RESIDENTIAL REMODEL

1201 GARDNER AVE

MEMORANDUM

Re: 1201 Gardner new submission

PROPOSED FIRST FLOOR
SCALE: 1/8"=1'

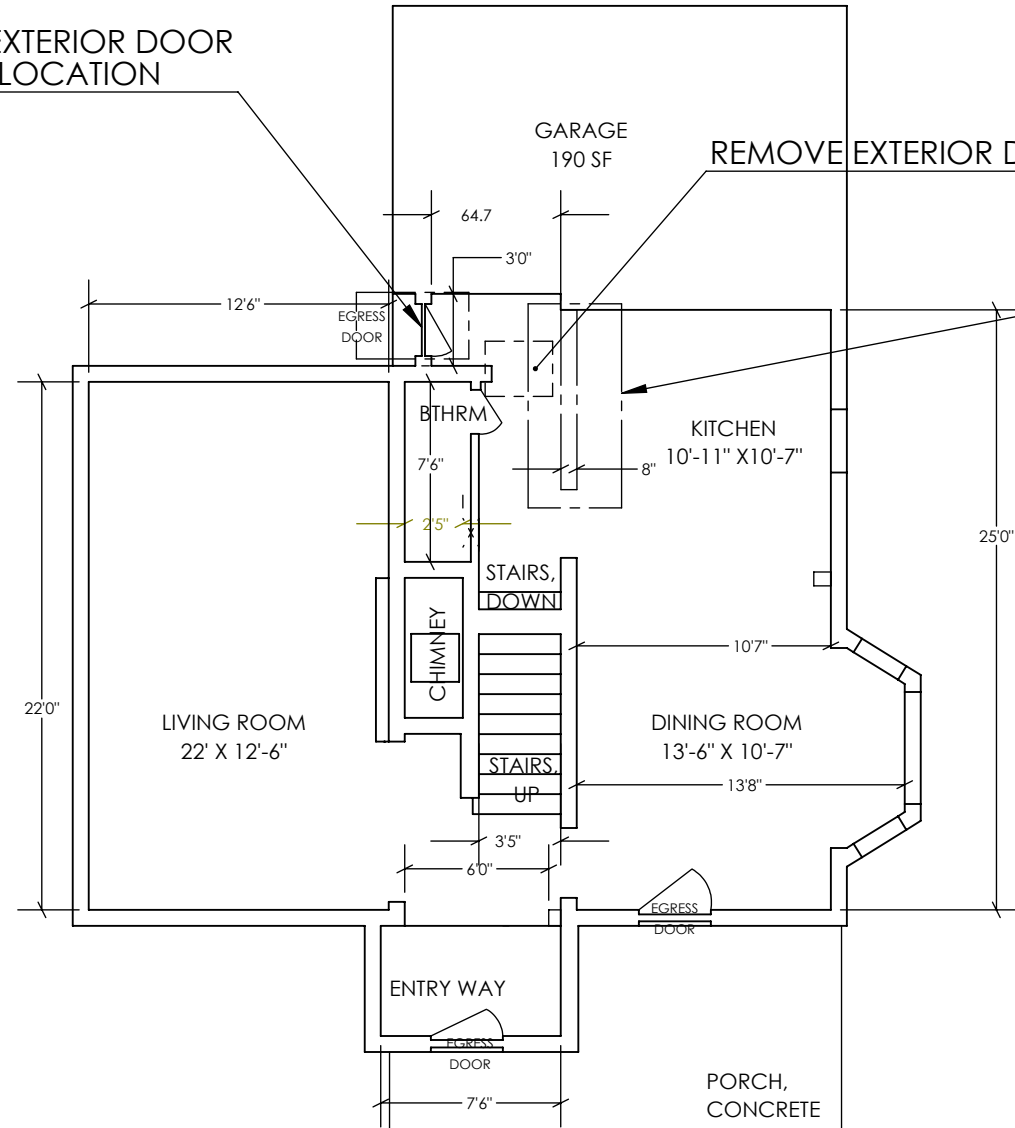
At the April 11, 2024 HDC meeting the application at 1201 Gardner was postponed to allow the applicant to adjust and complete the proposal to relocate the home's back door. The attached revised drawings show the door turned 90 degrees (from facing south to facing east) and inset approximately 1'7" into the breezeway, which is currently 7' deep (assuming the measurement of 64.7 shown on the proposed plan is in inches).

Per the drawings, the existing door would be reused. No new stairs are shown; the historic one-step-up to the breezeway would be maintained, with a second step up into the doorway. The HDC will need to determine whether the amount of inset is adequate to insure the integrity of the breezeway. The April 11 staff report is attached after the new drawing set.
